Service Bulletin

Bulletin No.: 16-NA-252

Subject: Information on Rear Tire Front Air Deflector Missing One Fastener Per Side

4568517

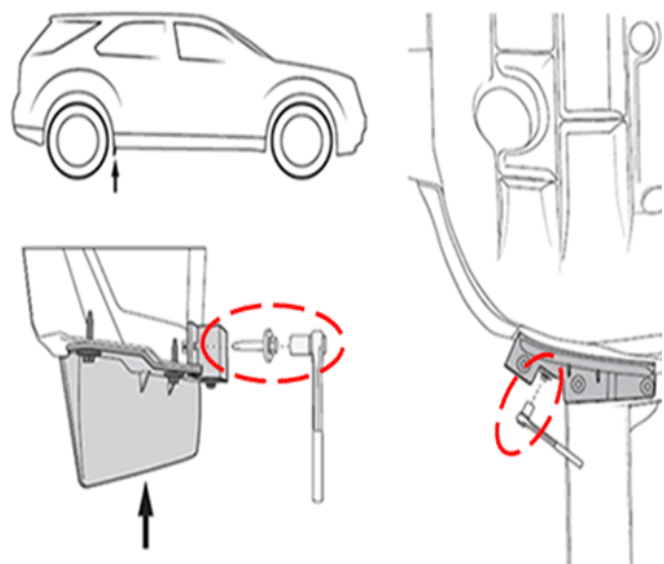
Involved Region or Country	North America and N.A. Export Regions
Additional Options (RPOs)	PLANT CODE-INGERSOLL, ONT, CANADA (CAMI) — (NGT)
Condition	During Pre Delivery Inspection (PDI), a technician may find two bolts and an instruction sheet in a loose part bag, and/or may find both rear tire front air deflectors missing one fastener per side.
Cause	The cause of the condition may be that the assembly plant was unable to install the rear tire front air deflector fasteners at these two locations.

1. Reaching under the rocker panel, feel along the rear tire front air deflector for the open hole at the **only horizontal** fastener location, shown circled in the illustration above.

Install both missing rear tire front air deflector bolts (one per side) from the supplied service kit found in the loose part bag. If kit is missing, order a replacement kit using the Parts Information below.

2. Install the bolt and tighten to 2.5 N•m (22 lb in).
3. Repeat bolt installation on the opposite side.
